September 2017
FL741AB
NHTSA #17V-451

Subject: FCCC XCR Chassis Battery Cables

**Models Affected: Specific Freightliner Custom Chassis
XCR chassis manufactured November 27, 2012, through
February 23, 2016.**

Fig. 1, Battery Cable Bracket, Correct Installation

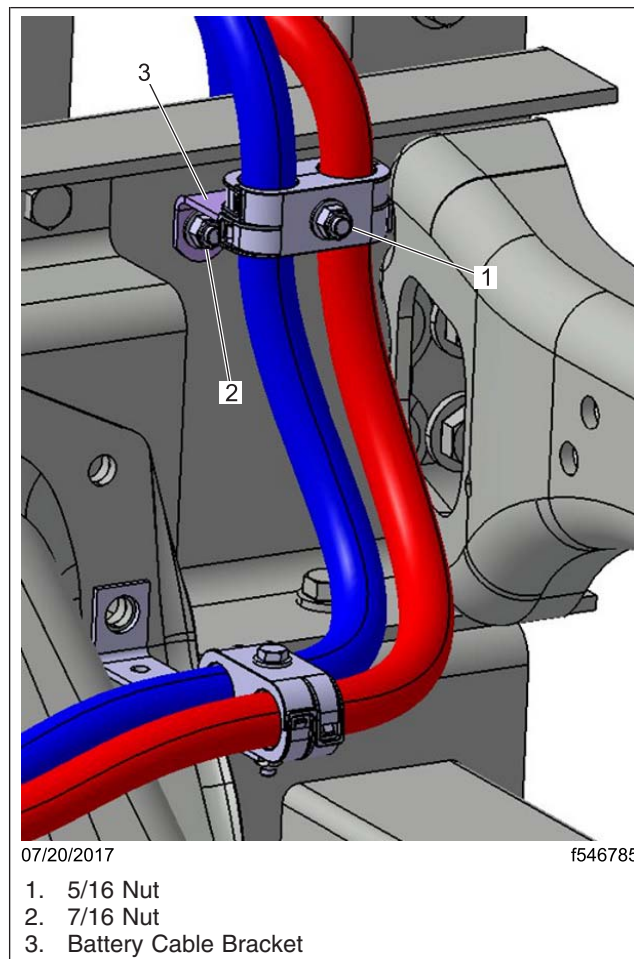
On certain vehicles a battery cable mounting bracket may have been incorrectly installed causing the battery cable to be improperly routed. If improperly routed, the battery cable may come in close proximity to the frame rail and cause rubbing or shorting of the cable. A potential battery cable short between the cable and the frame rail may increase the risk of a fire.

1. Remove the 5/16 nut and washer from the portion of the bracket holding the battery cables and set the nut and washer aside.
2. Loosen the 7/16 nut that attaches the battery cable bracket to the frame rail and correctly rotate the bracket as shown in [Fig. 1](#).
3. If the battery cable bracket is missing, install it on the frame rail using the 7/16 nut and washer assembly. See [Fig. 1](#) for proper installation.

4. Tighten the 7/16 nut and washer assembly 42 lbf·ft (57 N·m).

5. Install the battery cables in the battery cable clamp and use the 5/16 nut and washer to secure the clamp on the bracket. Tighten 15 lbf·ft (20 N·m).
6. Clean a spot on the base label (Form WAR259). Write the recall number, FL741, on a blank red completion sticker (Form WAR260), and attach it to the base label to indicate this recall has been completed.

Fig. 2, Battery Cables Rubbing the Frame Rail

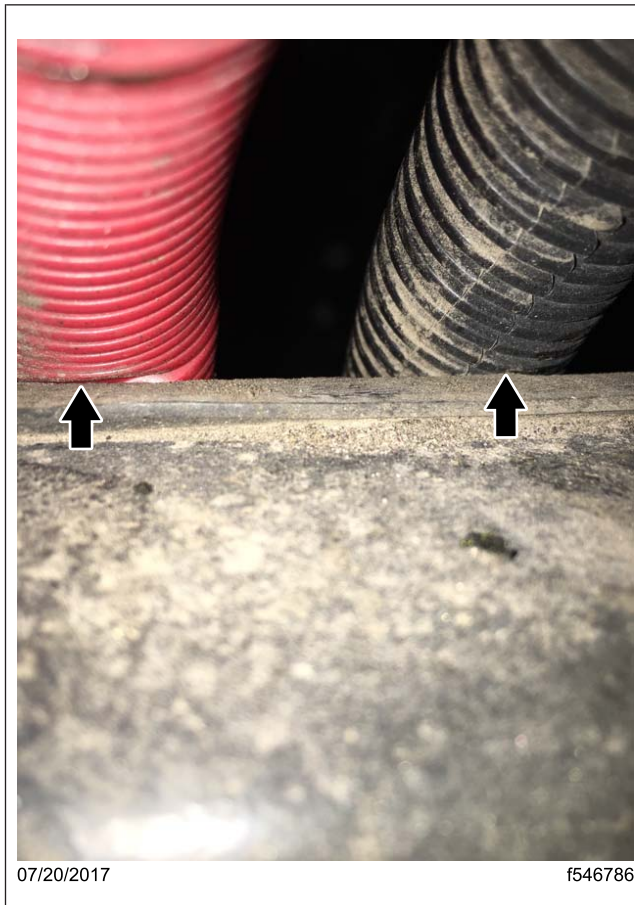
- If the battery cable bracket is incorrectly installed or missing, inspect the battery cables for damage. It is possible for the conduit that covers the cable to be damaged, but the battery cables are not damaged. Damage to the battery cables could include, but is not limited to, a cut in the battery cable or visible cable insulation. See [Fig. 2](#) and [Fig. 3](#). After inspection of the battery cable, go to 'Battery Cable Bracket Procedure.'

The battery cables were rubbing the frame rail but are not damaged, and do not require replacement.

IMPORTANT: If the battery cable(s) are damaged, replace the battery cable(s). It is possible for the conduit that covers the cable to be damaged, but the battery cables are not damaged. Damage to the battery cables could include, but is not limited to, a cut in the battery cable or visible cable insulation. See [Fig. 2](#) and [Fig. 3](#)
